FIELD SERVICE BULLETIN

FSB Number: LVCCFSB2005-118
Authors: Darwin Garcia
Date: April 26, 2005
Total No. of Pages: 2
Subject: **MPX220 Incomplete SW Download**
Model Affected: **MPX220**
Level of Repair: 2

M-Logo Screen

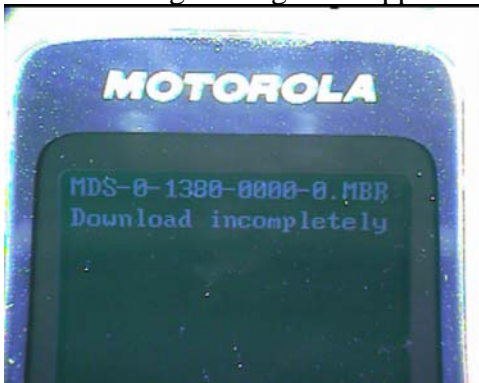
Service has detected an incomplete SW download issue during MPX220 NPI process. Phones are being return for “Hang/Freeze” complaints. ODM's analysis determined that the software was not fully downloaded to the phone during reflash at the DC or field software upgrade. When the software is not fully downloaded the phone will hang on the M-logo screen when first turn on.

Warning Message

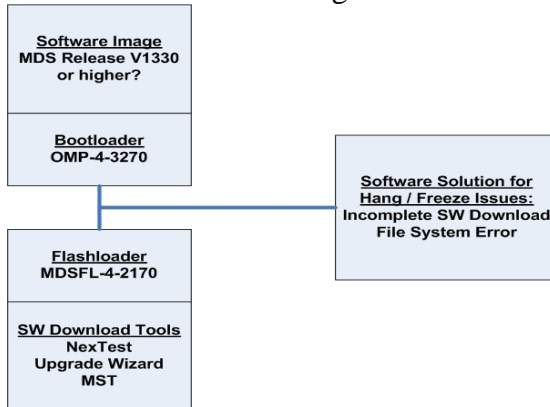
The new boot loader (OMP_Loader 3.270) and flash loader (2.170) in combination have a checking mechanism that if the device was not downloaded successfully, it won't boot and a warning message will appear on the screen.

The new boot loader (OMP_Loader 3.270) is compatible with SW version 1.33 or higher and it can be combined into a one flash file pending local SW approval. Implementing the new flash loader on the DC tool (Nextest) is dependent of the local SW approval. However the new flash loader was implemented on service download tool Upgrade Wizard 1.8.10 and if using MST select the correct flash loader on the download option.
